**Re: Response to Transportation Comments
48 Grenoble Drive
City File: 22 127125 NNY 16 OZ/ 22 137124 NNY 16 SA
Project No.: 300054545.0000**

R.J. Burnside & Associates Limited (Burnside) has reviewed the City of Toronto's (the City) transportation related comments within the Engineering & Construction Services Memorandum, dated May 25, 2022, and City Planning Division North York District letter, dated September 2, 2022.

MANEUVERING ANALYSIS - GROUND CITY REAR PACKER REFUSE TRUCK

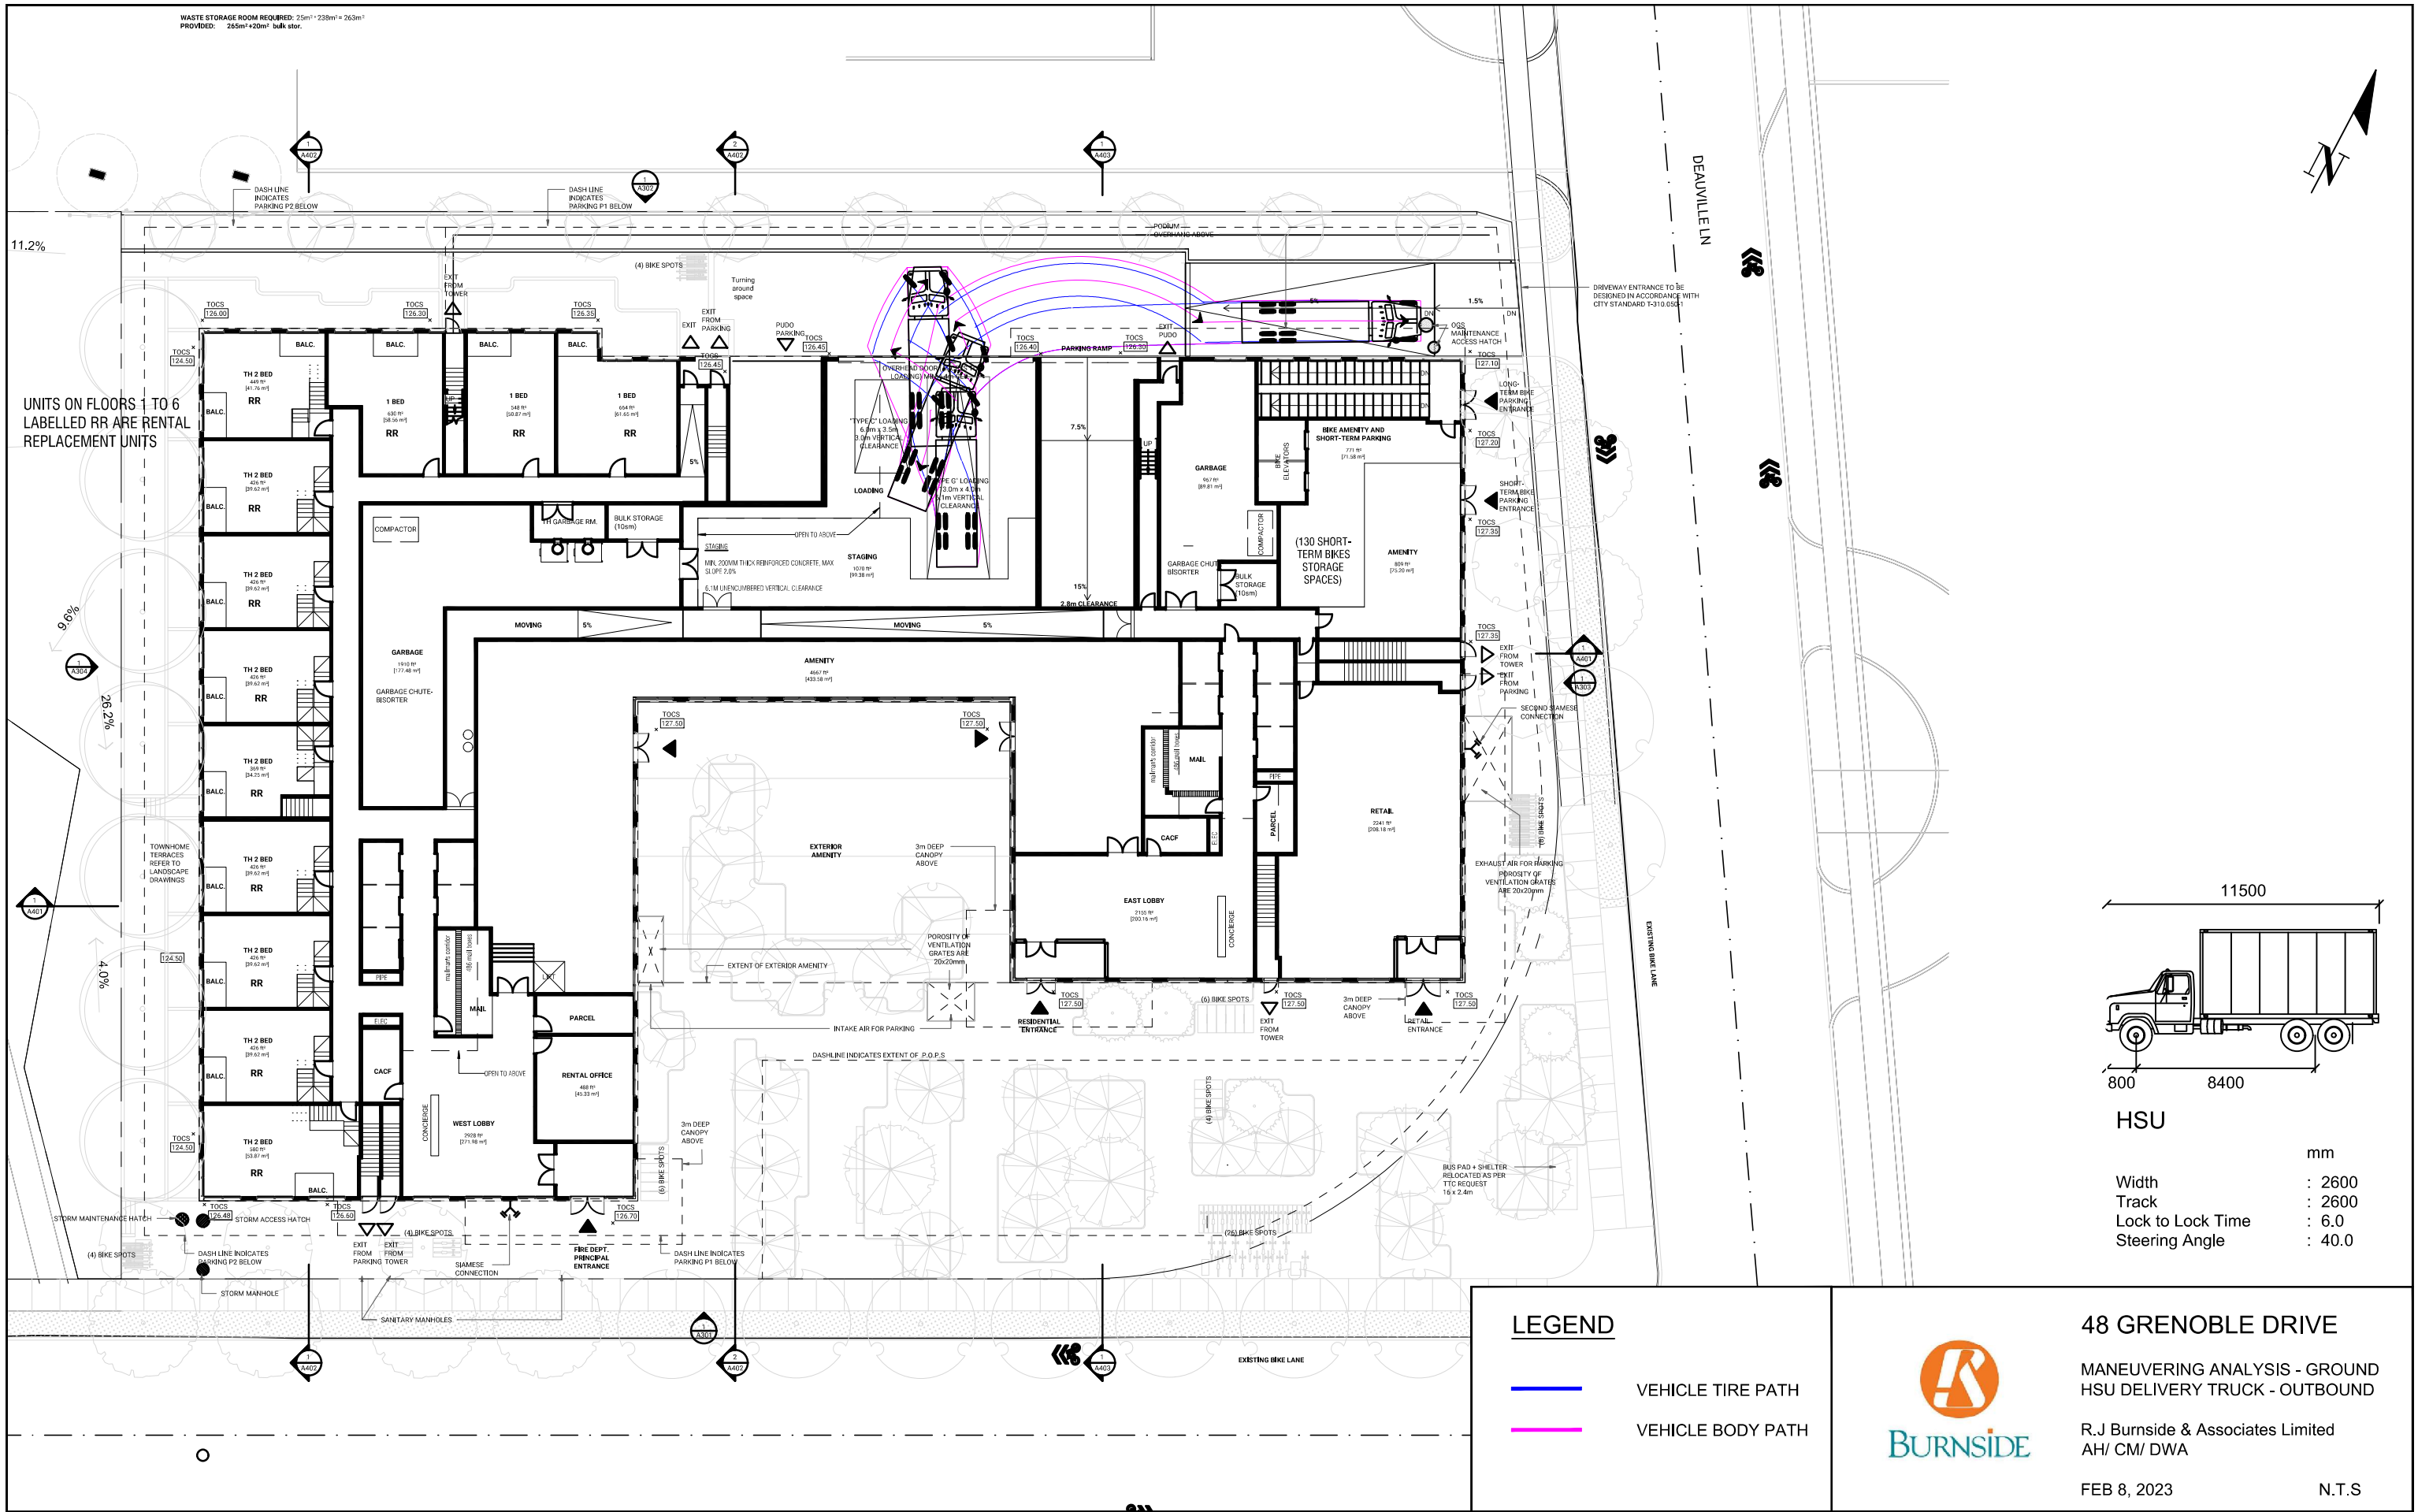
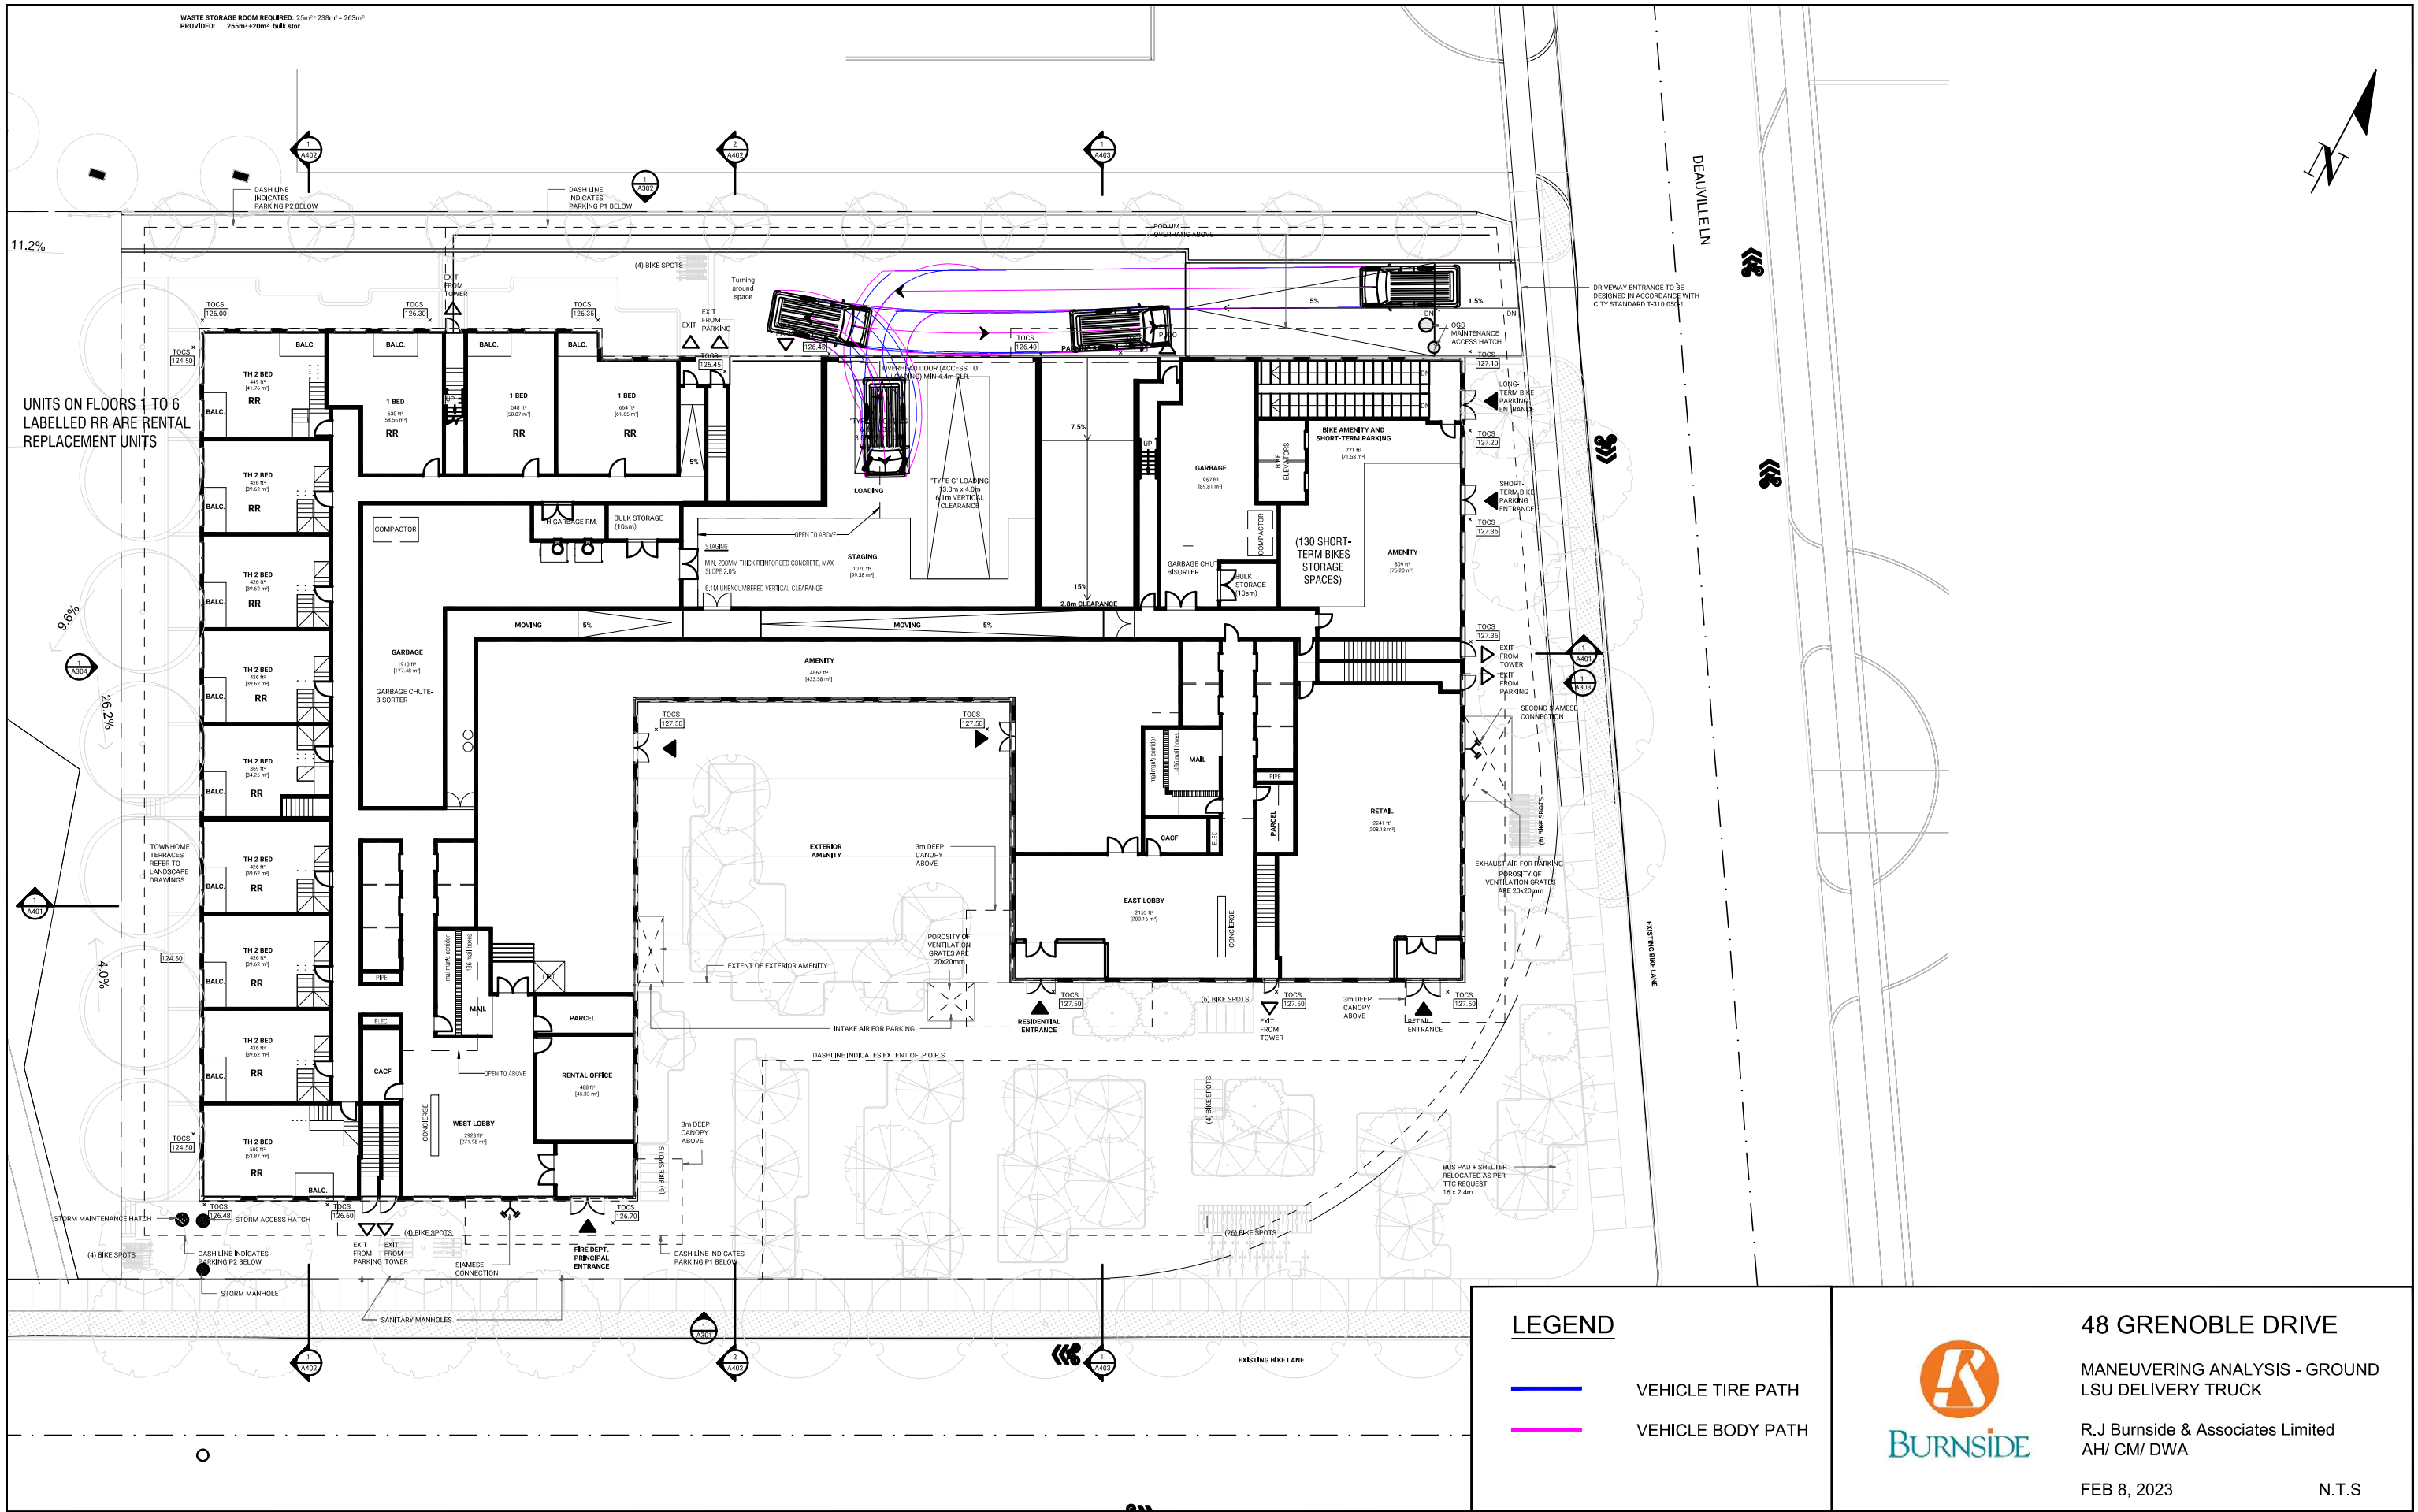
1.2.6. Revised drawings must indicate and annotate a collection vehicle movement diagram that has a length of 12 metres and a width of 2.4 metres with a minimum inside/outside turning radii of 9.5 metres and 14 metres respectively, when entering, exiting, travelling throughout the site and entering/exiting the type G loading space. The diagram must also indicate the ability of the collection vehicle to enter and exit the site in a forward motion with no more than a three-point turn.

Updated collection vehicle movement diagrams are provided in Attachment 3, which satisfies the requirements noted.
